**Subject: RESPONSE TO REQUEST FOR ADDITIONAL INFORMATION FOR
THE RIO ALGOM LLC'S APPLICATION FOR GROUND WATER
ALTERNATE CONCENTRATION LIMITS DATED JANUARY 16,2003**

Response to Request for Additional Information

**Corrective Action Program and Alternate
Concentration Limits Petition for
Uppermost Bedrock Units
Ambrosia Lake Uranium Mill Facility
Near Grants, New Mexico**

**Application for Alternate Concentration Limits in
the Alluvial Materials at the
Quivira Mill Facility
Ambrosia Lake, New Mexico**

Figure 1. Sensitivity analysis using the midrange of each parameter for initial model input and then varying each parameter across its range one parameter at a time.

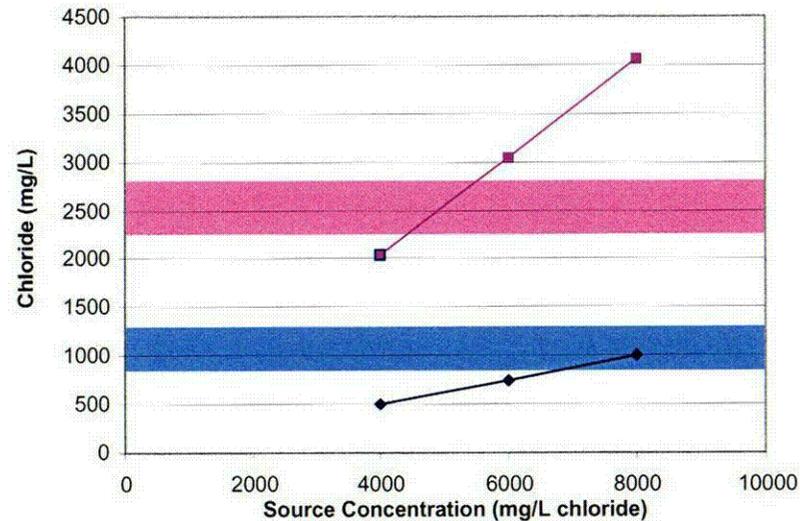
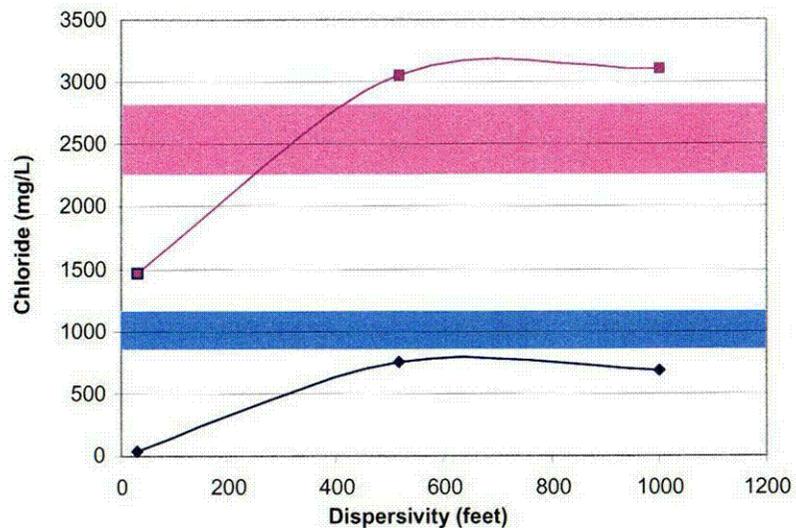
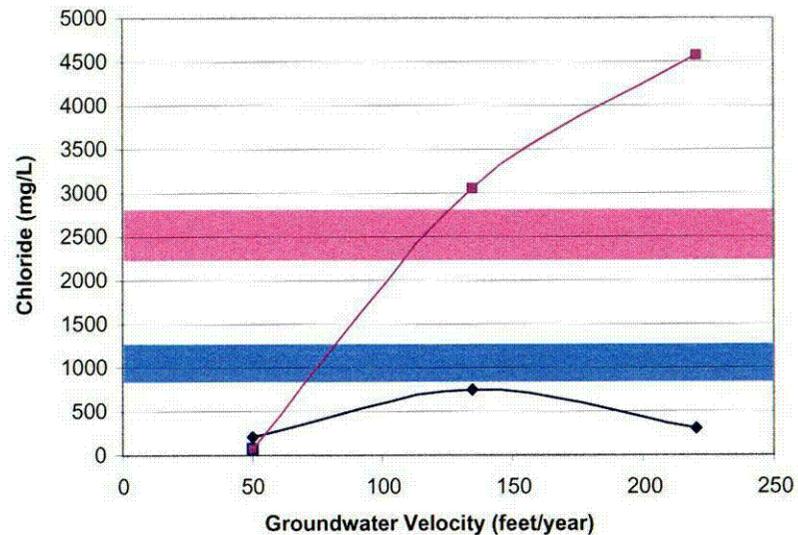
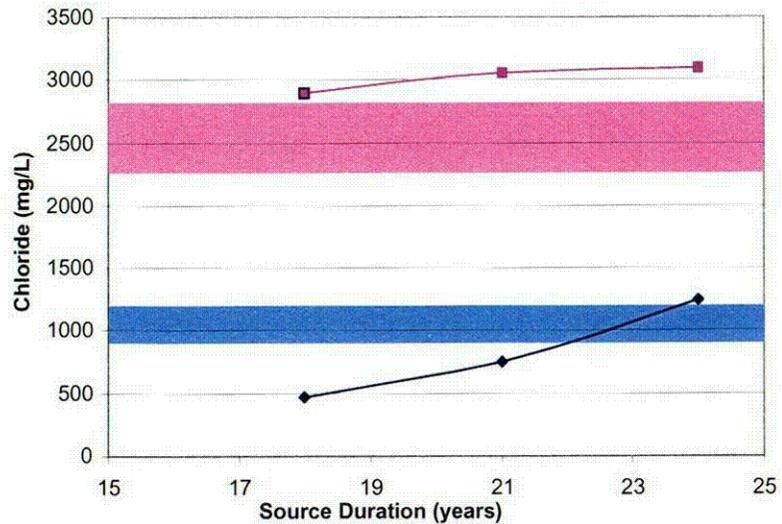
Using the SOLUTE code (Beljin and van der Heijde, Version 2.00, 1993) transport model results to estimate attenuation factors between point of compliance (POC) and POE locations seems reasonable; however, the effect of parameter uncertainty on the calculated attenuation factor has not been evaluated.

REQUIRED ACTION: Rio Algom should provide an uncertainty analysis for the calculations used to estimate contaminant attenuation factors. Documentation of these analyses should include the range of attenuation factors that can be estimated from a set of transport calculations that can be reasonably calibrated to match observed chloride and U-nat concentrations, considering the uncertainty in groundwater velocity, dispersion lengths, uranium retardation factor, and source concentration variability. It should be shown, based on this uncertainty analysis that the attenuation factors used to calculate proposed health-based ACLs are reasonable and not overly optimistic. As part of this analysis, provide an explanation for the recent trends at well 36-06KD (i.e., rising chloride and U-nat, and descending pH).

The sensitivity analysis consisted of choosing the midrange of each parameter for initial model input and then varying each parameter across its range one parameter at a time. Other parameters were held constant at the midrange during each model run. Figure 1 presents the results of the sensitivity analysis for each parameter along with concentration targets for POC well 36-06KD and POE well 36-04KD. Calibration targets were developed from the range of concentrations observed in those wells during the 1992 to 1994 time period (years 31-33 from the start of the model). Results show that the best fit for all parameters is closer to the middle of each range, rather than at any extreme. Model results are relatively insensitive to variations in some parameters (specifically source duration and dispersivity above 500 feet) while calibration targets can only be matched in a narrow range for others (specifically groundwater velocity and source concentration). Therefore, statistical goodness of fit analyses were not considered necessary. The final optimized model for chloride transport (Figure 2) used the following values:

Figure 3. Time Concentration Plots for Constituents of Concern in Monitor Well 36-06KD.

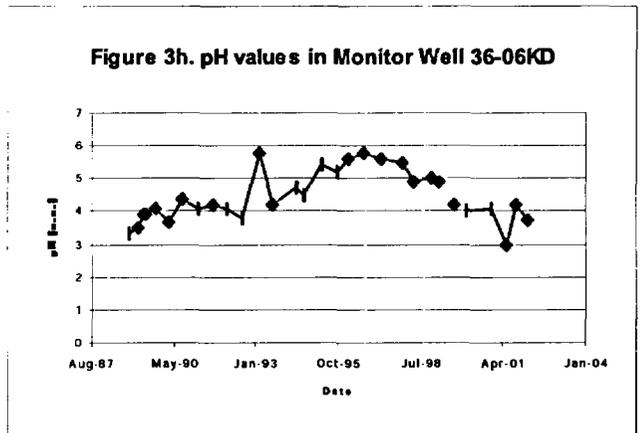
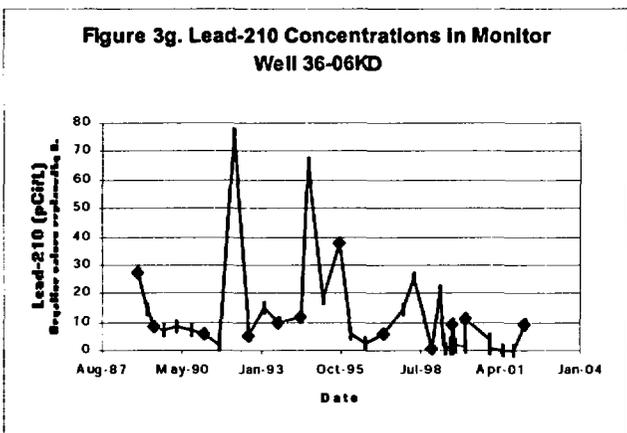
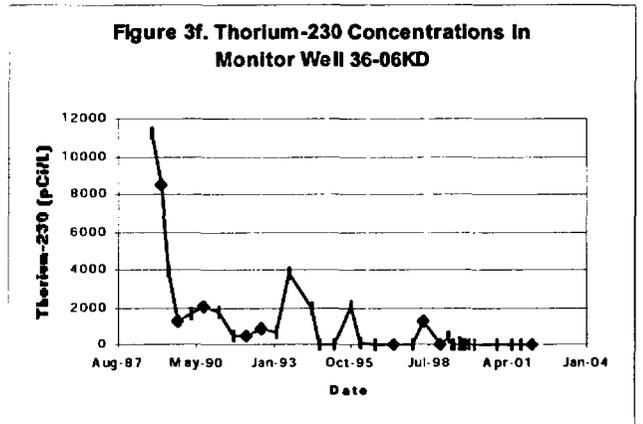
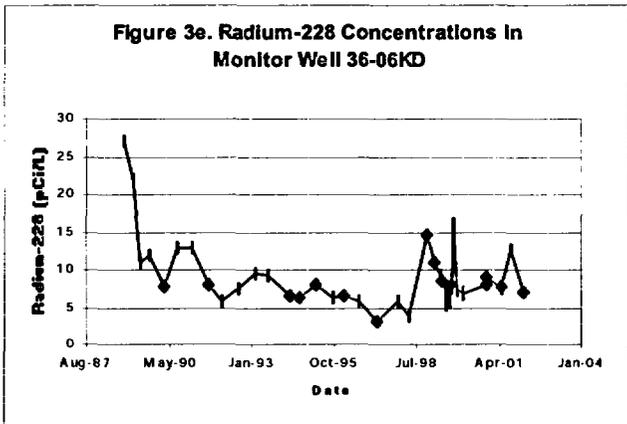
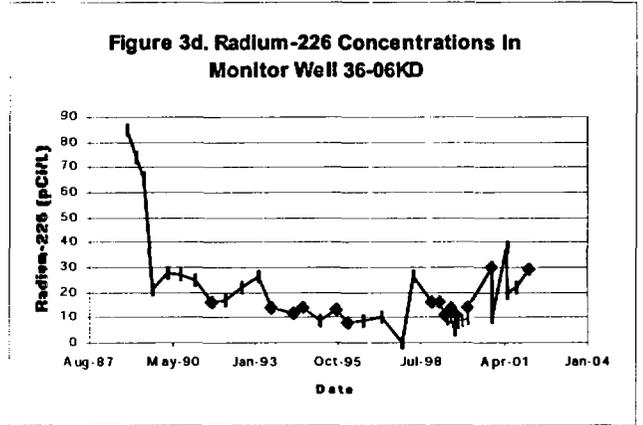
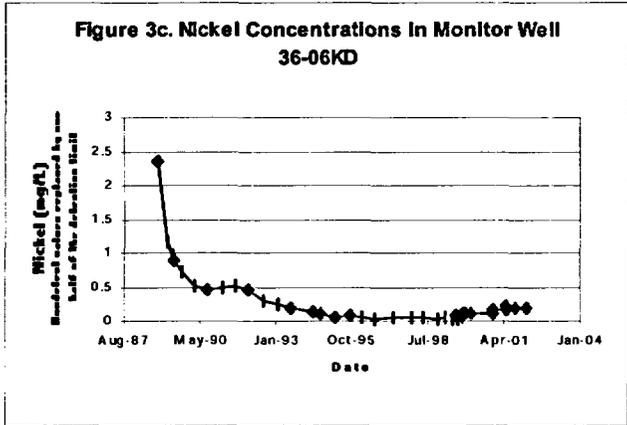
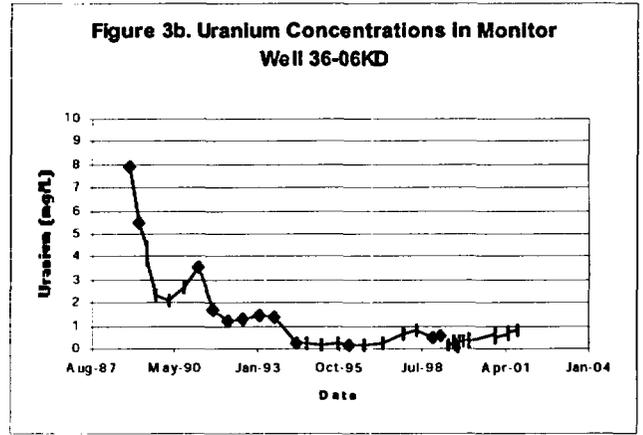
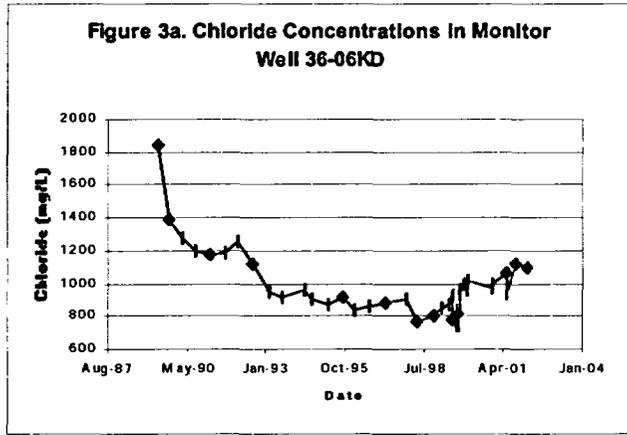
A basis is required for the assertion that applying the uranium attenuation factor to all other contaminants is conservative because uranium is the most mobile of the group.

REQUIRED ACTION: Provide the technical basis for the assertion that “U-nat is the most mobile of the hazardous constituents of concern” (bedrock aquifer application, p. 2-34).

Constituent trends are evident in data reported for Monitor Well 36-06KD. The chloride trend in Monitor Well 36-06KD is markedly similar to trends exhibited by concentrations of uranium and nickel in the same well (Figures 3b and 3c). Radium-226 and radium-228 exhibit similar trends (Figures 3d and 3e), though less smooth and with more noise. Concentrations of Thorium-230 start high and then drop to mainly non-detect (Figure 3f), without the concentration rise in recent data seen in other trends. Lead-210 exhibits no apparent trend (Figure 3g). pH rises from a low near 3 to a high near 6 before it begins to drop again in 1997 or 1998 (Figure 3h).

These data from Monitor Well 36-06KD suggest several transport conditions as summarized below:

- The similarity in periodicity of chloride, uranium, nickel, and radium suggest that in these low pH waters, these constituents traveled at a similar velocity.
- Radium trends are not as well defined as chloride, uranium and nickel trends, suggesting that radium transport may not be as continuous or as fast as chloride, uranium, and nickel.
- The transport velocity of thorium and lead is likely slower than the other constituents.

Simplified Geologic Map of the QMC Site Showing Location of Vent Holes and Subcrop of the Tres Hermanos B Sandstone Beneath the Alluvium.

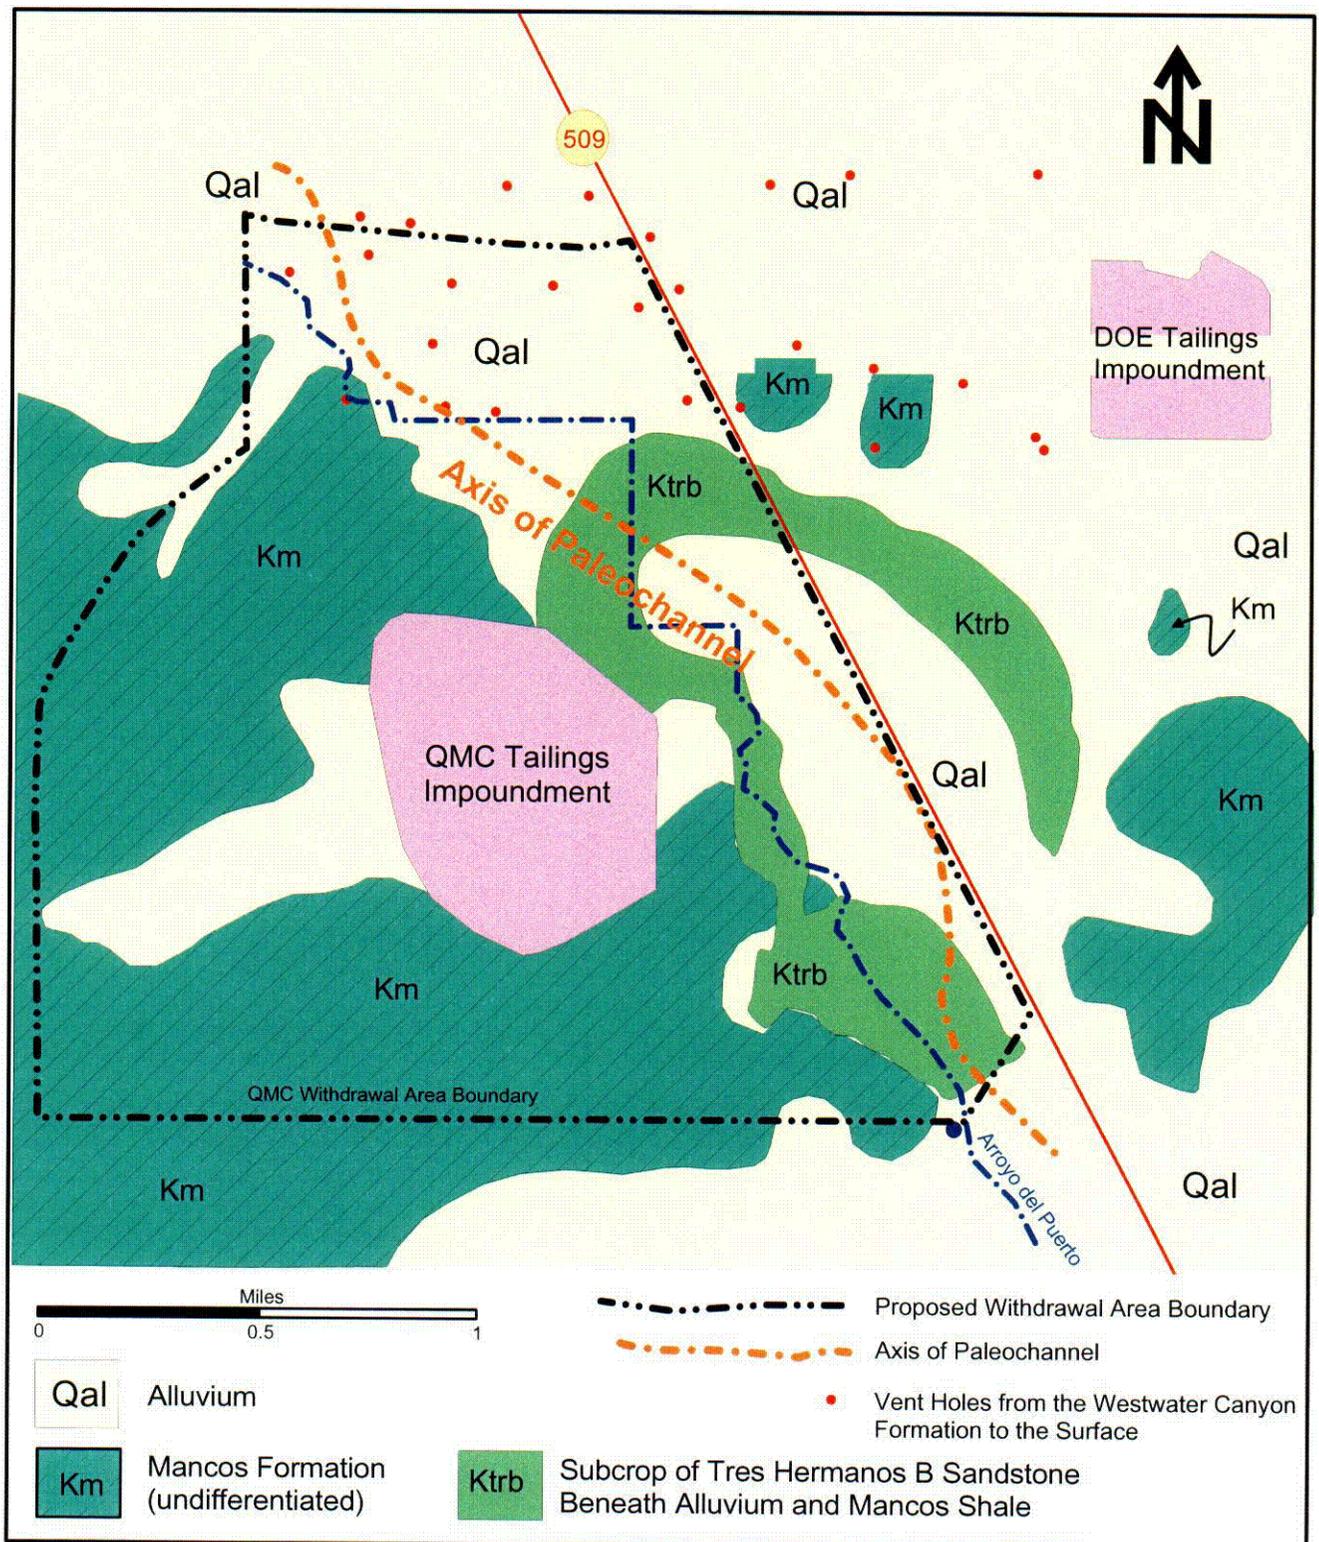
Much of the groundwater currently in the alluvial formation is expected to drain into the Tres Hermanos A (TRA) and Tres Hermanos B (TRB) bedrock units, but the application contains no discussion or analysis of fate and transport of contaminated alluvial-system drainage in the bedrock formations.

REQUIRED ACTION: Rio Algom should provide fate and transport assessments for constituents of concern entering the uppermost bedrock units as drainage from the overlying alluvial formations.

A simplified geologic map of the Rio Algom site showing the subcrop of the Tres Hermanos B is presented in Figure 9. Also shown are vent holes from the Westwater Canyon Formation to the surface. The transport of constituents from the Rio Algom site to the Tres Hermanos B will be along the following pathway: Constituents may originate at either the tailings impoundment or an unlined evaporation pond, infiltrate the Alluvium, move from the Alluvium to the Tres Hermanos B west of the Arroyo del Puerto bypass, move down dip in the Tres Hermanos B to the north and northeast (Bedrock ACL Application) where they will ultimately be contained by the hydrologic depression created by over 40 years of mine pumping in the valley.

Figure 11. Model for uranium transport in the Alluvium

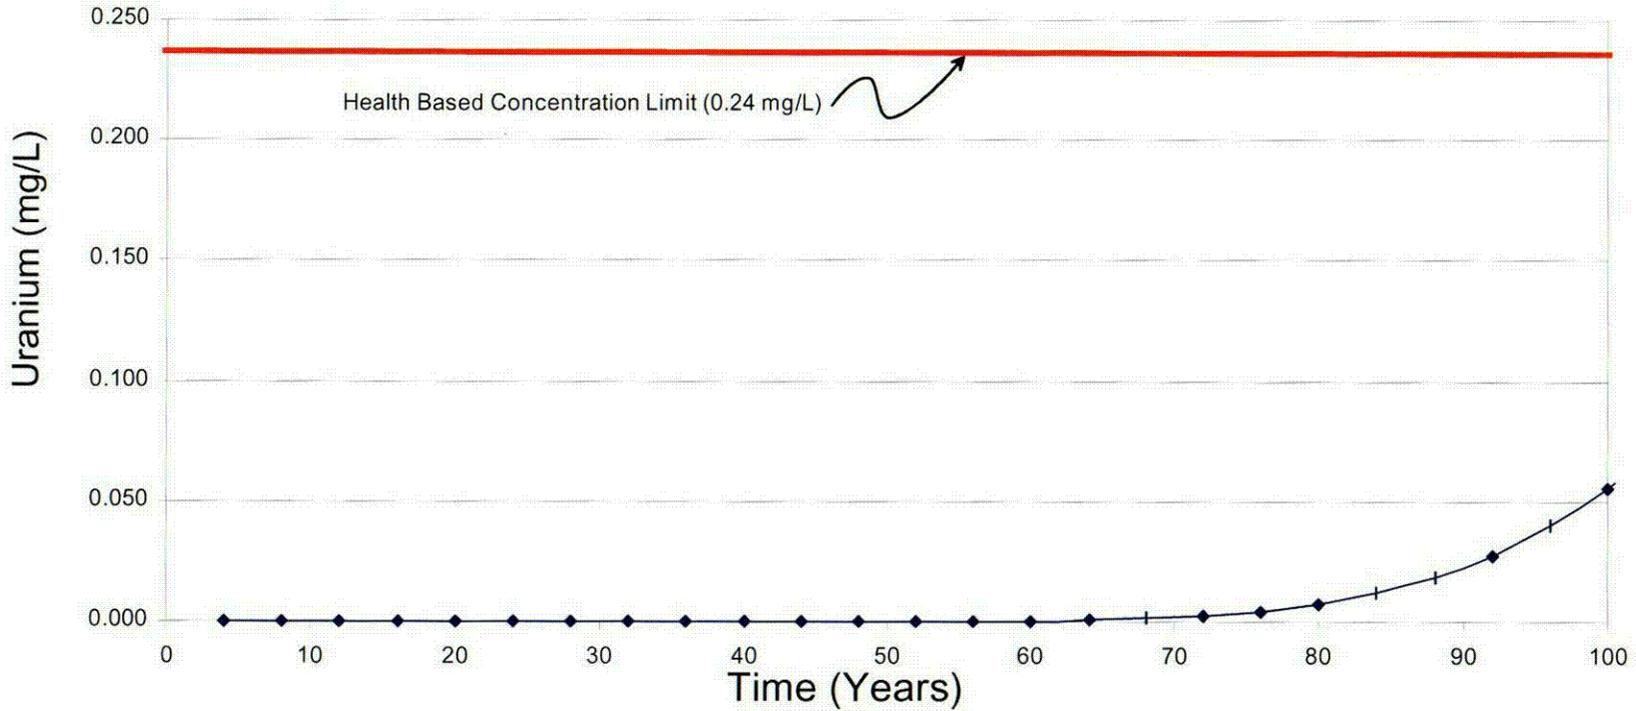
REQUIRED ACTION: Provide a more thorough technical basis for the geochemical model, or revise the model. If the model is not better constrained or revised, provide alternative demonstrations of the alluvial attenuation capacity or abandon reliance on attenuation.

One way to provide an indication of transport from the Rio Algom side of the Alluvium is to ignore other sources and do a one dimensional SOLUTE transport model similar to the one applied to the simpler groundwater system in the Dakota. This is done with the understanding that distributions of constituents from sources other than Rio Algom will not be accounted for in the model, and therefore, the model cannot be calibrated.

Uranium modeling for the Alluvium (Figure 11) shows that the proposed ACL based on the following: a background concentration of 11.1 mg/L, a distance of 5,500 feet from alluvial POC well 31-61 to the POE, and assumptions similar to those used for the Dakota, results in a POE concentration of 0.056 mg/L in 100 years. The 100-year time frame is based on groundwater flow modeling that demonstrates almost complete dewatering of the Alluvium within 100 years. The modeled POE concentration of 0.056 mg/L for uranium results in an attenuation factor of 0.005. The attenuation factor of 0.005 is applied to background levels of constituents of concern as shown in Table 4, along with health-based concentrations.

Ground Water Table Elevation Map
Ambrosia Lake Area
Near Grants, New Mexico
FIGURE

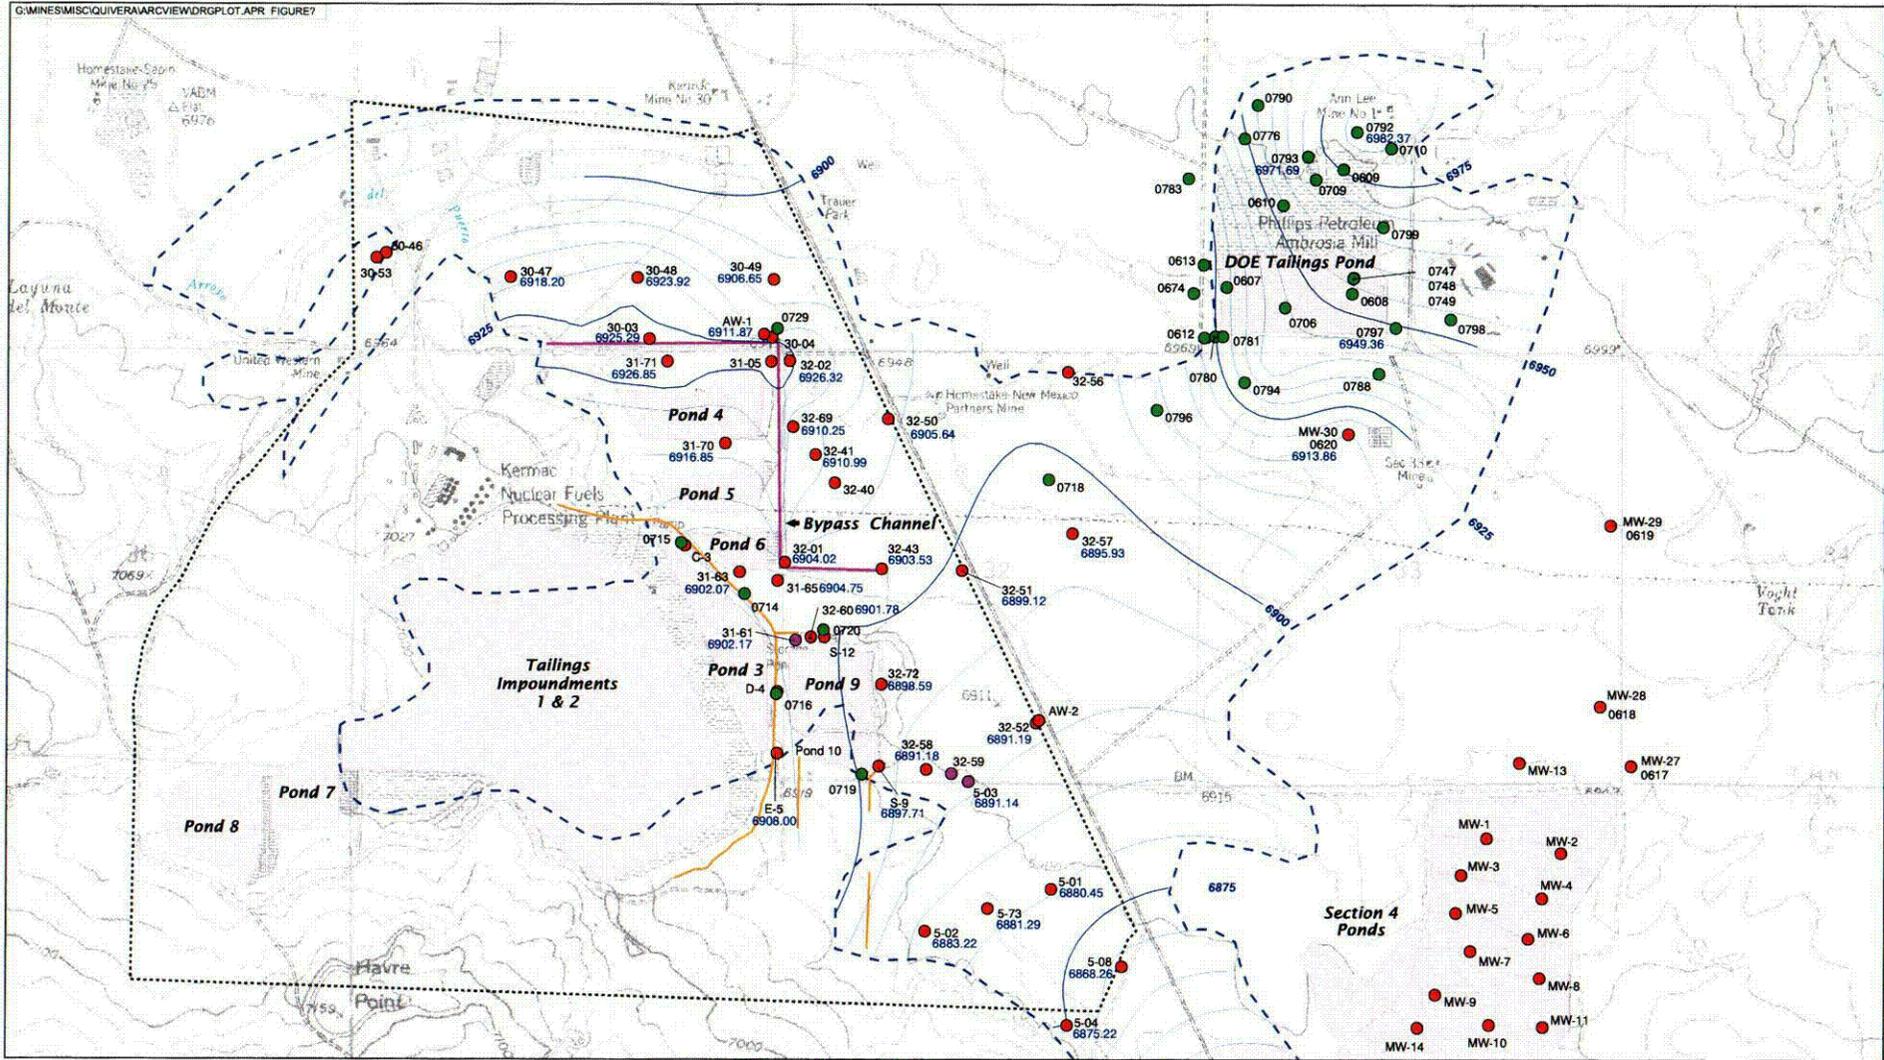
REQUIRED ACTION: Provide the technical basis for flow as represented in the “groundwater sweep” model. If appropriate, re-draw the groundwater elevation contours on Figure 2.17.

See the redrawn groundwater elevation contours presented in Figure 2.17 included as Figure 12 of this document.
